ATTACHMENT 1

City of Ryde Submission Woolworths CFC and Warehouse, 144 Wicks Road Macquarie Park

SSD-48853239

**Submission Date: 05 June 2025
COR2023/61/1**

Figure 9: Mark up of Applicants Plan showing Required Roads (Base Source: Nettleton Tribe)

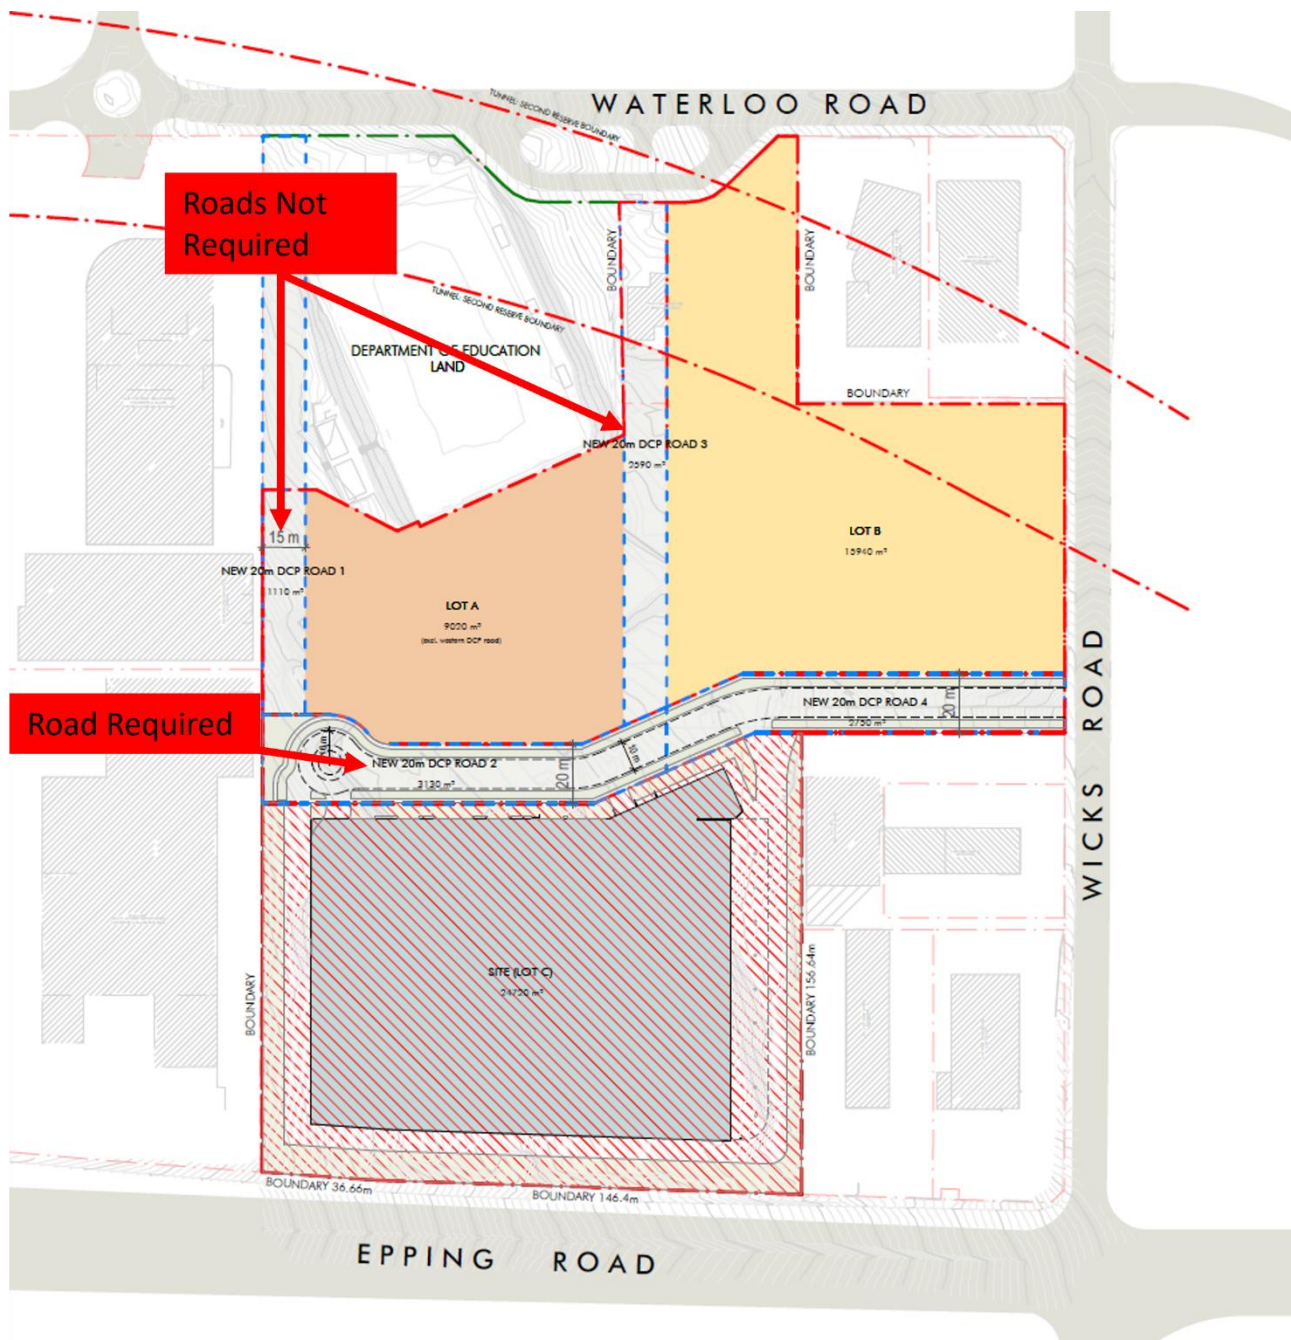
The proposal also includes two new roads (Figure 9) being a 15m road and 20m width road reserve extending south from Waterloo Road to Road No.4.

- The architectural plans are amended to remove the two roads from Waterloo Road
- The architectural plans are updated to show the Wicks Park.

In summary road No.4 extending from Wicks Road, along the southern boundary of Lots A and B is required to be constructed and dedicated to Council in accordance with the requirements of the Updated Design Guide. The other two roads extending from Waterloo Road to the southern boundary of the site are not required public roads but as open space under the Macquarie Park Design Guide.

Figure 10: Mark up of Civil Plans showing required road in red to be dedicated to Council

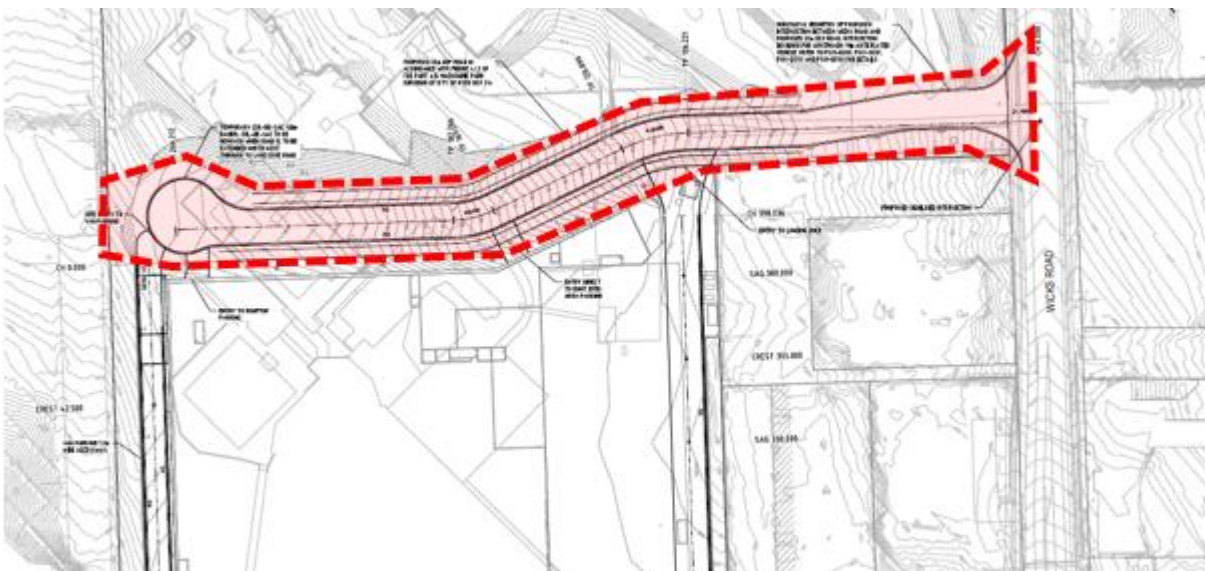
A new road central to the lot extending from Wicks Road, along the southern boundaries of Lots A and B must be constructed and dedicated to Council as per the Updated Design Guide issued by DPHI upon finalisation of the Macquarie Park rezoning proposal in November 2024.

The new road is to be dedicated to Council as specified in the Design Guide. The new road must extend up to the boundary to facilitate continuation upon the development of the adjoining lot – 61-65 Epping Road. The plans provided show an interim cul-de-sac termination approximately 10-15m from the boundary with 61-65 Epping Road. The plans must be revised to show the road extending to the boundary of 61-65 Epping Road. Upon future extension of the road, the cul-de-sac arrangement would become redundant as it would function as a through road.

The plans should address future turning paths for heavy vehicles, when the new road extension is delivered as part of the adjoining development. If the cul-de-sac is being used to accommodate necessary heavy vehicle management, a consideration needs to be made of how these manoeuvres will be achieved once the through road connection is made.

Figure 11: Extract from Macquarie Park Design Guide Showing Road Reserve Design (Source: Macquarie Park Design Guide)

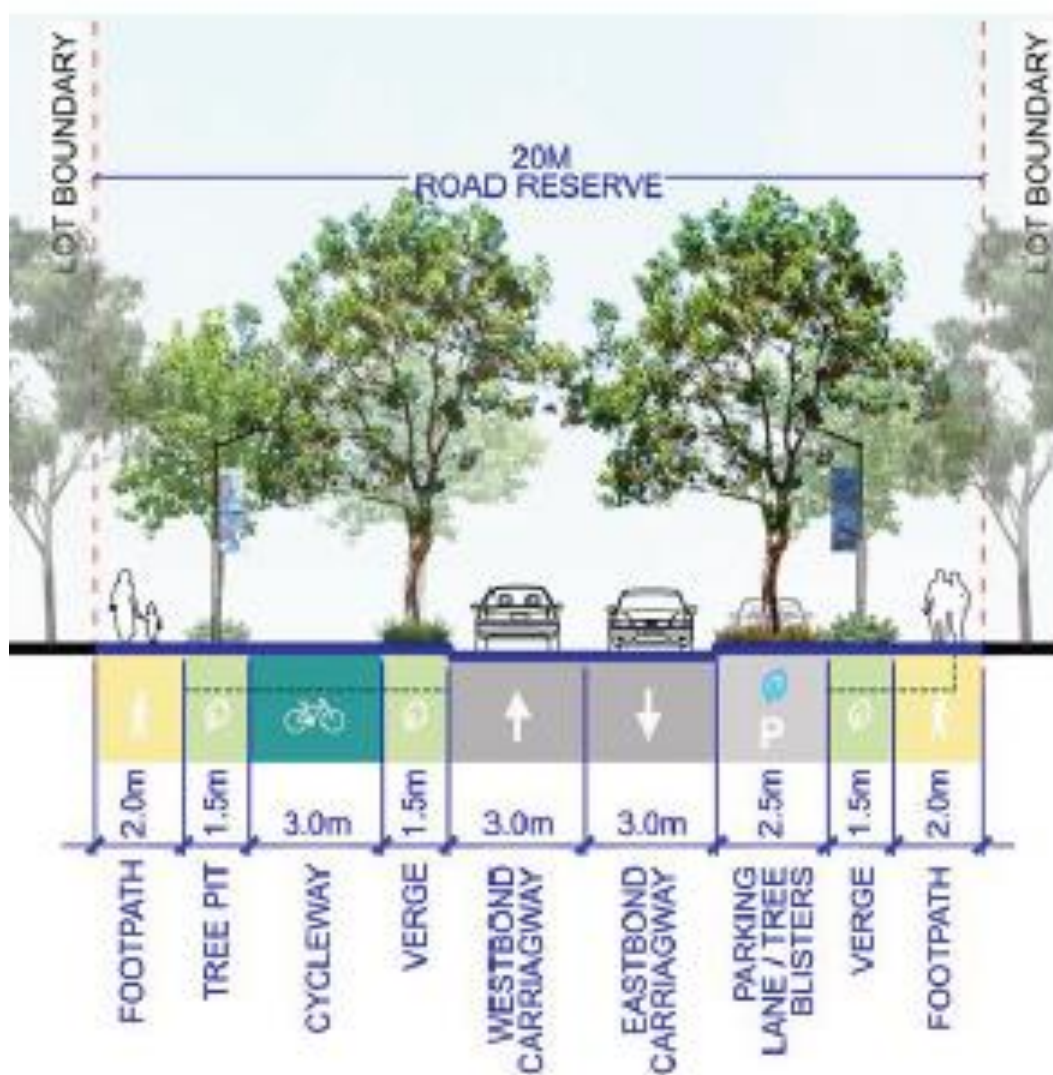
The plans need to demonstrate consistency with the below figure that shows the design requirement for street type 'ST7'.
